Findings, Conclusions and Decision Public Works Variance EN-22-0014

Site: The Reserve Preliminary Plat
Parcel No. 0222323134

Re: **(EN-22-0014)** The Reserve Preliminary Plat Approach Landing - Public Works Variance Request

RE: The Reserve — CPH Project No. 0228-21-001
Request for Public Works Standards Variance for Intersection Landing Length
City of Gig Harbor Permit No. EN-22-0014

FIGURE 2 -
PRELIMINARY ROAD A
PLAN AND PROFILE

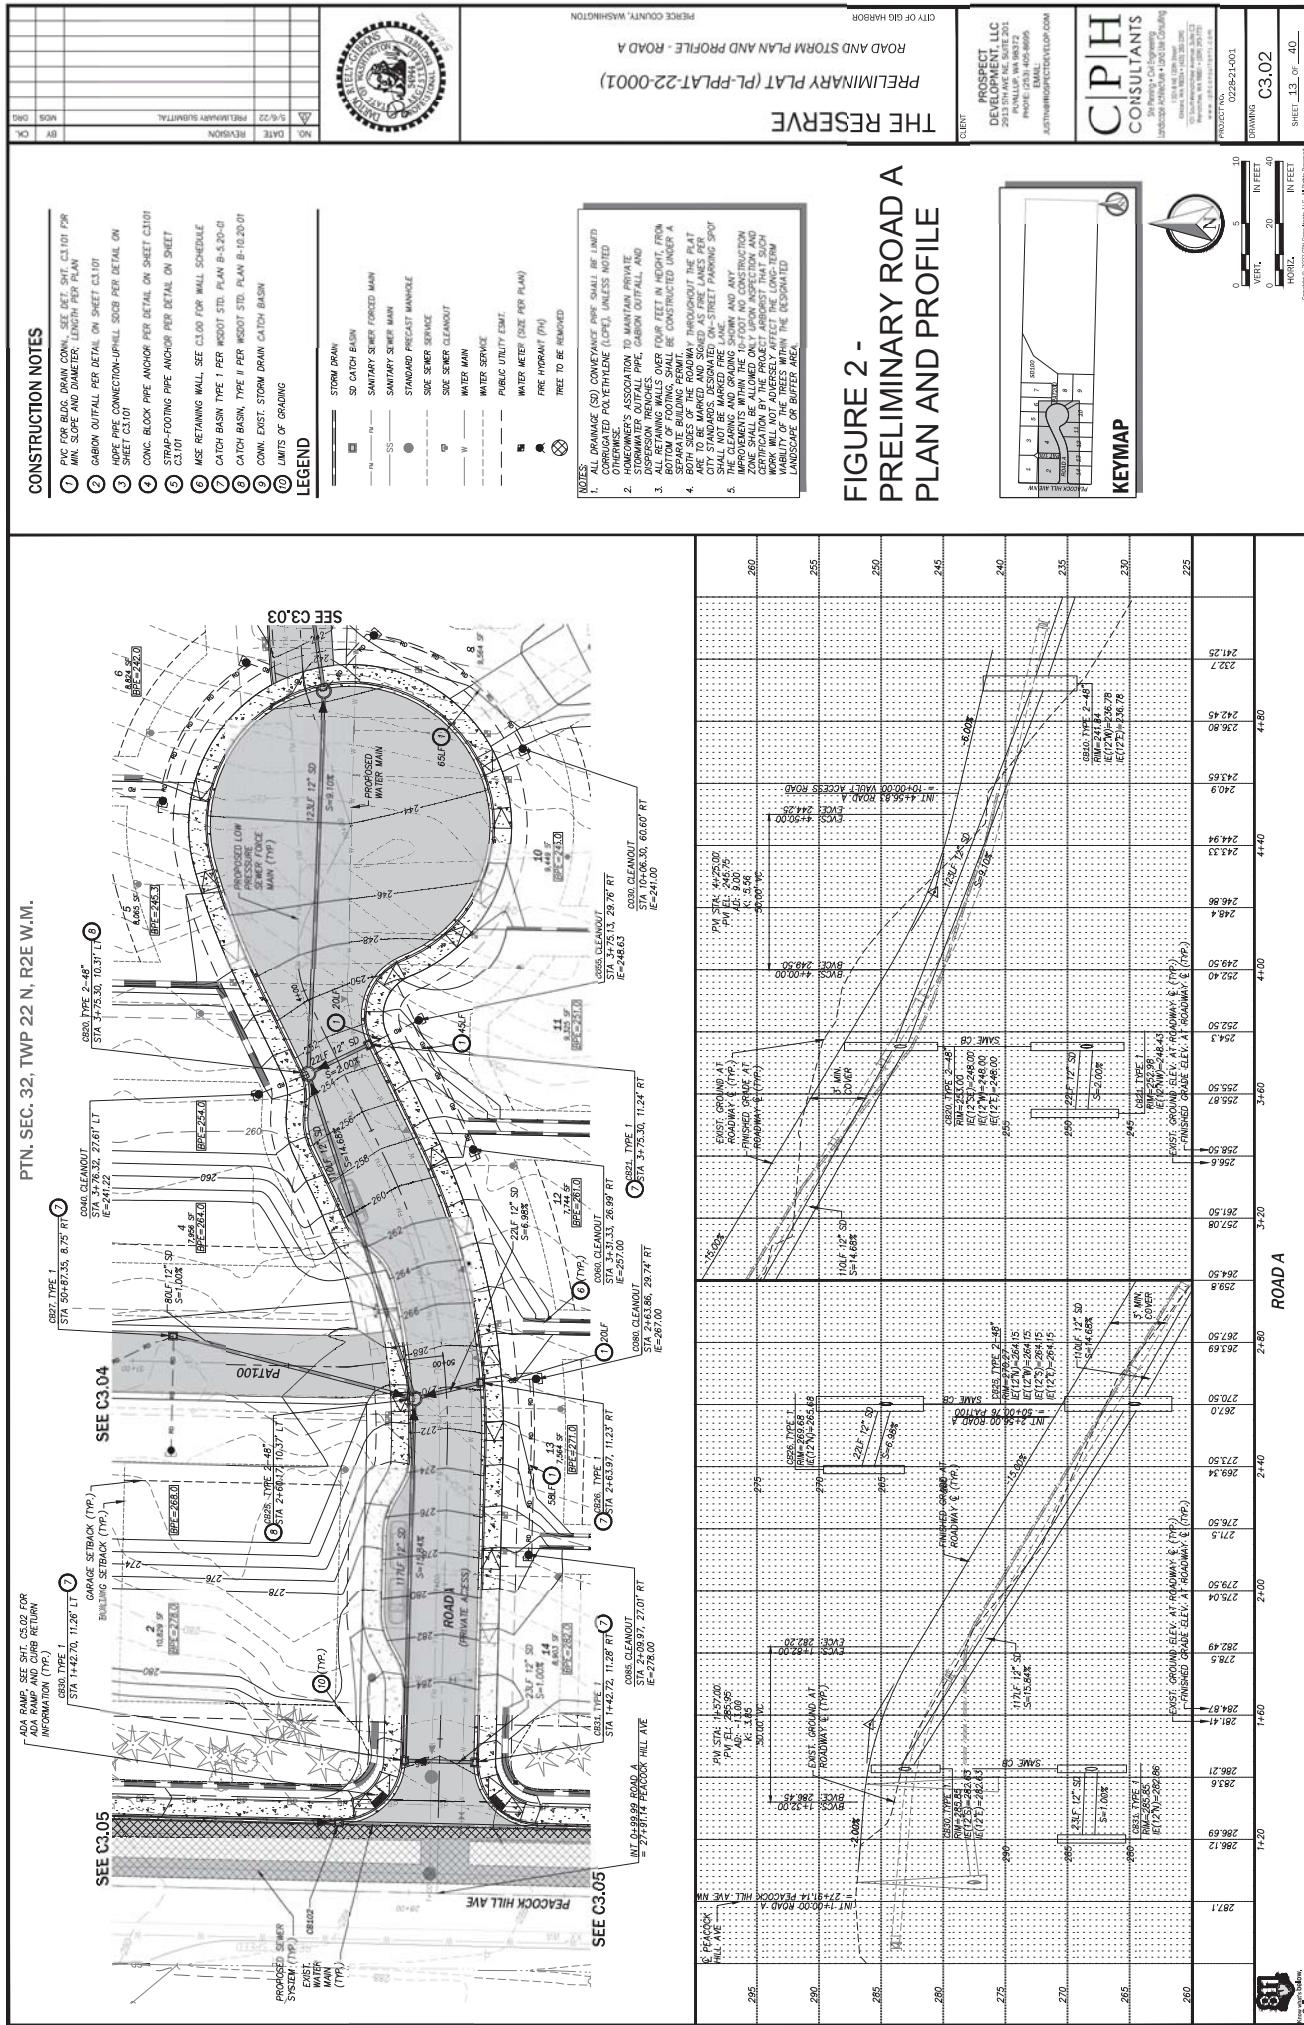
The Reserve site has significant topographic relief that under existing conditions falls at an approximately 15% grade from the existing edge of pavement approximately 17 feet from the centerline of Peacock Hill Avenue NW to approximately 500 feet east in the site where steeper slopes as high as 45% exist. The project roadway design and measurement of the vehicular landing from the existing travelled way instead of the right-of-way limit of Peacock Hill Avenue is proposed to reduce the amount of fill and height of walls that would be required to accommodate these existing topographic conditions. The proposed edge of traveled way will be 17 feet from the existing centerline of Peacock Hill Avenue and this traveled way will consist of a 12-foot driving lane and 5-foot bike lane consistent with the current conditions present on Peacock Hill Avenue. Please see the attached plan and profile exhibits for reference.

The PWS section 2B.140.B requires that intersections with sloping approaches provide a landing not exceeding 3% for 30 feet approaching any arterial as measured from the nearest right-of-way line. This is undesirable due to the slopes existing on the site. Beginning the 30-foot landing measurement at the right-of-way line, 30 feet from centerline, as opposed to the edge to the traveled way, 17 feet from centerline, causes an elevation increase over the length of the road of approximately 1.6 feet. This elevation increase results in a substantial increase in required fill material of approximately 10,000 cubic yards and increased wall heights throughout the site.

The City Engineer's analysis has concluded that the requested variation is functionally equivalent to and is consistent with the intent of Section 2B.140(B).

The City Engineer's analysis concludes that the Applicant has demonstrated that the proposed landing conforms with the intent of Section 2B.140(B) of the City of Gig Harbor Public Works Standards. The requested variance meets sound engineering practice as indicated.

FIGURE 3 - TYPICAL ROAD SECTIONS

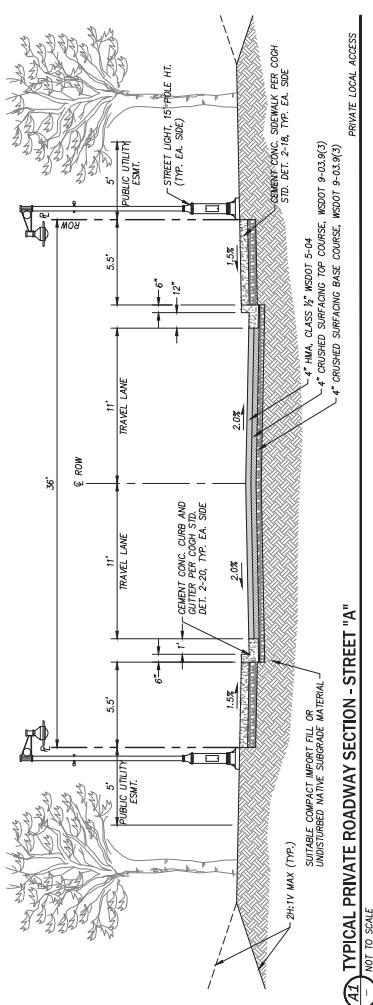
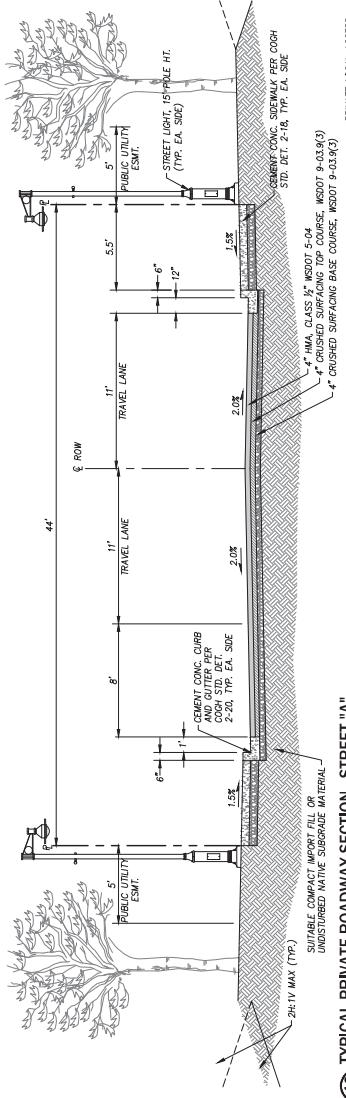
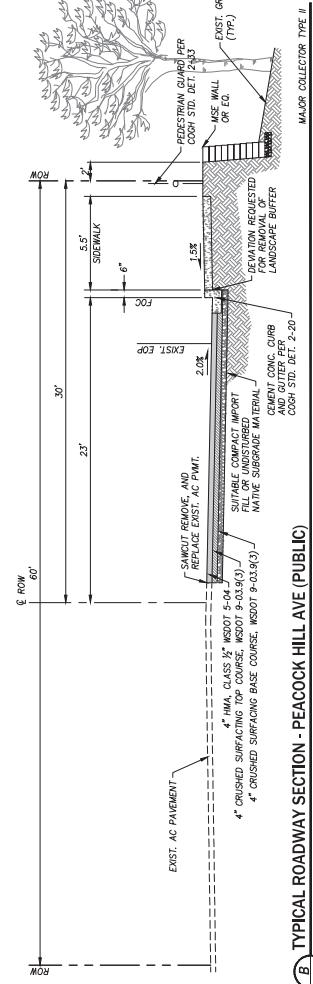
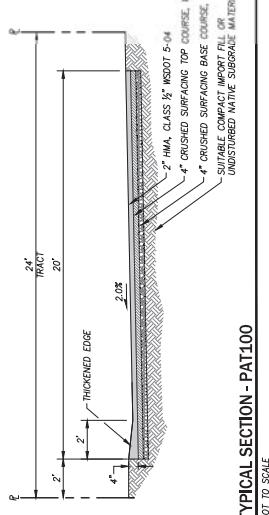
The proposed variation is consistent with the intent of the PWS section 2B.140.B because it provides a 30-foot safe landing for vehicles prior to entering the traveled way of the minor arterial, Peacock Hill Avenue NW. This will provide a landing of 3% or less for 1.5 times the length of average size vehicles and maintains adequate sight distance for existing vehicles. Adjusting the landing measurement point out to the right-of-way as stated in the PWS section 2B.140.B would create a landing that is 43 feet long prior to entry into the traveled way of Peacock Hill Avenue. While a longer landing provides more room for vehicles exiting the project site, the fact that the project is proposing a low volume, dead-end road with only 14 single-family residential lots suggests that the additional queuing/staging length is not warranted.
